Item Name: Crosstube Assembly, Mid Fwd

DART AEROSPACE LTD	Work Order:	164158
Description: Crosstube Assembly, Mid Fwd	Part Number:	D206-667-147
Inspection Dwg: D206-667-147 Rev: A		Page 1 of 2

DRAWING NO. D206-667-147	TITLE CROSSTUBE ASS'Y (206L MID FWD)	REV. A	DART AEROSPACE LTD ENGINEERING ORDER		D.E.O. NO. D206-667-147-A-1	SHEET NO. SHEET 1 OF 1	SCALE NTS
DRAWN <i>qp</i>	CHECKED <i>ADS</i>	MFG. APPR. <i>JS</i>	APPROVED <i>MD</i>		DE APPR. <i>MD</i>		
DATE 11.07.15	DATE 11.07.20	DATE 11.07.21	DATE 11.07.21		DATE 11.07.21

DRAWING NO. D206-667-147	TITLE CROSSTUBE ASS'Y (206L MID FWD)	REV. A	DART AEROSPACE LTD ENGINEERING ORDER	D.E.O. NO. D206-667-147-A-2	SHEET NO. SHEET 1 OF 1	SCALE NTS
DRAWN AJS	CHECKED	MFG. APPR.	APPROVED	DE APPR.		
DATE 12.08.02	DATE 12.08.02	DATE 12.08.02	DATE 12.08.02	DATE 12.08.02	DATE 12.08.02

DETAIL P
BONDING STRAP INSTALLATION 2 PL

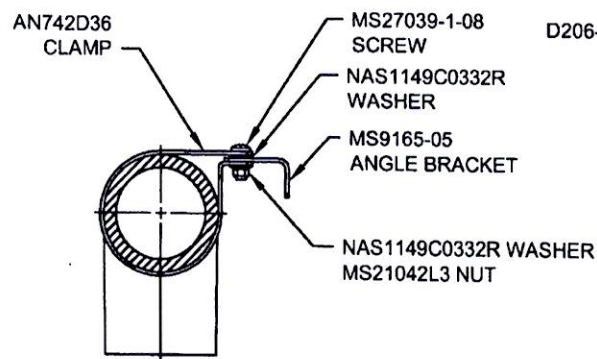
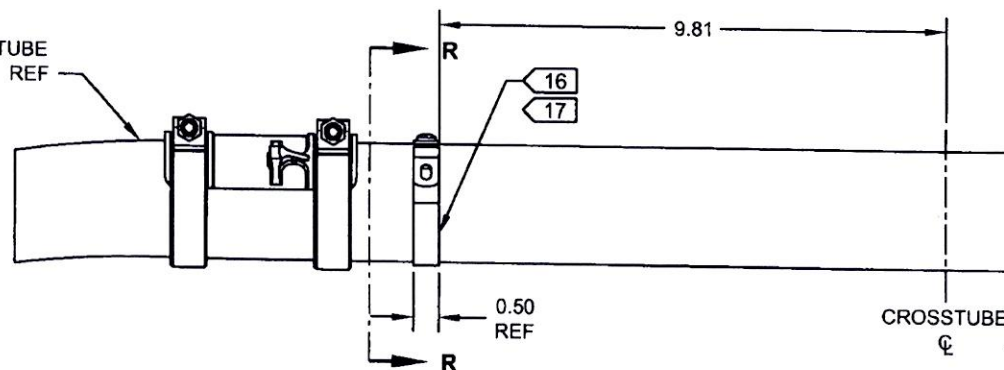
PURPOSE:

ADD ELECTRICAL GROUNDING STRAP

ADD

- 16) MASK AREA UNDER CLAMP PRIOR TO PAINTING
- 17) SEAL EDGES WHERE AN742D36 CLAMP MEETS WITH THE CROSSTUBE USING SIKAFLEX-241/-291 OR MIL-S-8802 CLASS B2 OR PROSEAL 890 SEALANT
- 18) PERFORM RESISTANCE CHECK TO ENSURE MAX RESISTANCE IS 10 MILLIOHMS

ITEM	QTY -147	PART NUMBER	DESCRIPTION
1	X	D206-667-147	CROSSTUBE ASSEMBLY (206L MID FWD)
10	2	AN742D36	CLAMP
11	2	MS9165-05	ANGLE BRACKET
12	2	MS21042L3	NUT (OR MS21042-3)
13	2	MS27039-1-08	SCREW
14	4	NAS1149C0332R	WASHER (OR AN960C10L)
